# HITACHI SEMICONDUCTOR TECHNICAL UPDATE

| Classification of Production | MPU  |         | No                            | TN-SH7-412A/E  | Rev            | 1 |
| THEME                        | SH7615/SH7616 limitation of DACKn output timing. |         | Classification of Information | 1. Spec change<br>2. Supplement of Documents<br>③ Limitation of Use<br>4. Change of Mask<br>5. Change of Production Line |                |   |
| PRODUCT NAME                 | HD6417615ARF<br>HD6417616RF                      | Lot No. | Reference Documents           | SH7615 Hardware Manual<br>ADE-602-198 Rev.1.0<br>SH7616 Hardware Manual<br>ADE-602-243 Rev.1.0                           | Effective Date |   |

Correct timing

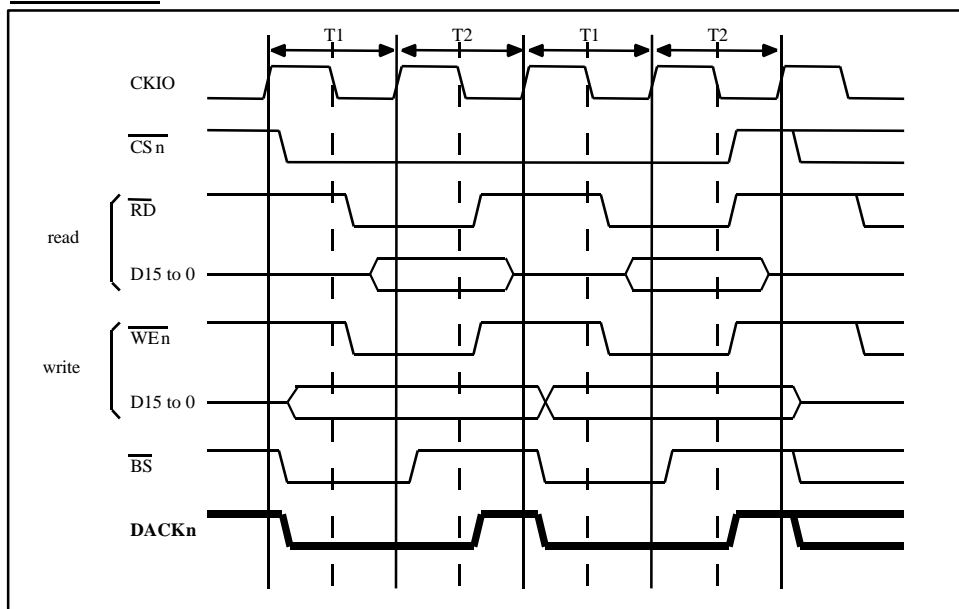
[Phenomenon]

When all following conditions are met, SH7615/SH7616 DACKn(n=0,1) outputs with "Error timing".

- (1) I<sub>0</sub>:E<sub>0</sub>=1:1.
- (2) DMA transfer to Ordinary space or Burst ROM.
- (3) 16-byte/Long word DMA transfer on 16-bit bus width or 16-byte/Long word/Word DMA transfer on 8-bit bus width.

- (1) Use frequency mode except Iø:Eø=1:1.
- (2) Use 32-bit bus width.
- (3) When the bus width is 16 bits, set DMA transfer size per Word unit or Byte unit.
- (4) When the bus width is 8 bits, set DMA transfer size per Byte unit.

Error timing (1)

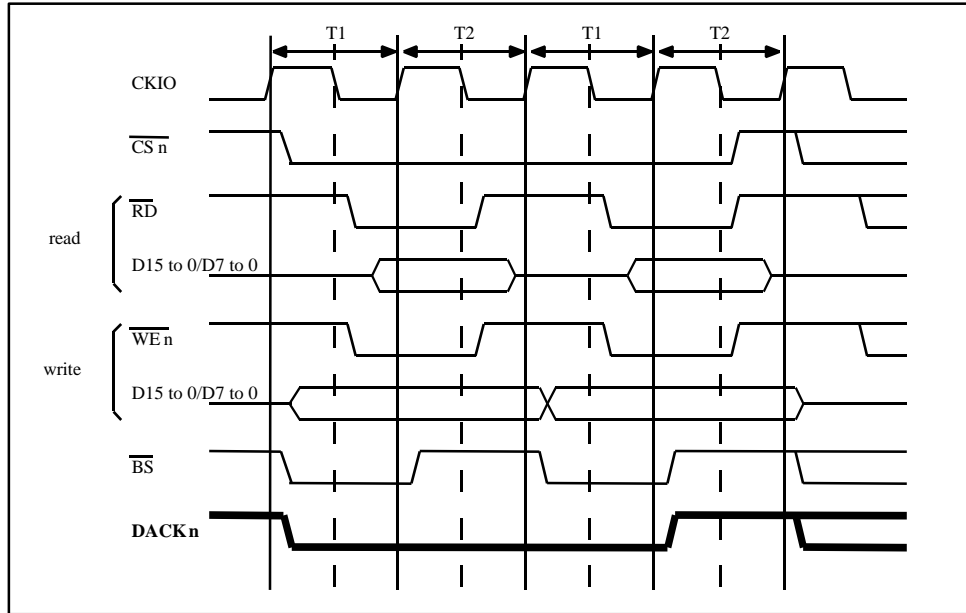
|                  | 16-byte unit        | Long word unit       | Word unit           |
|------------------|---------------------|----------------------|---------------------|
| 16-bit bus width | Error timing(1) x 4 | Error timing (1) x 1 | —                   |

Error timing (2)

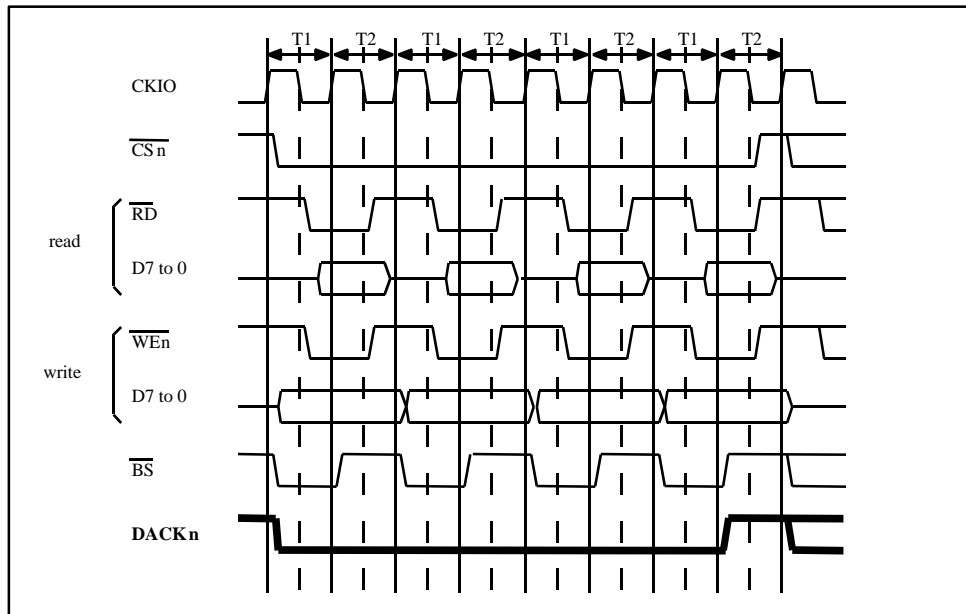
|                  | 16-byte unit        | Long word unit       | Word unit           |
|------------------|---------------------|----------------------|---------------------|
| 8-bit bus width  | Error timing(2) x 4 | Error timing (2) x 1 | Error timing(1) x 1 |
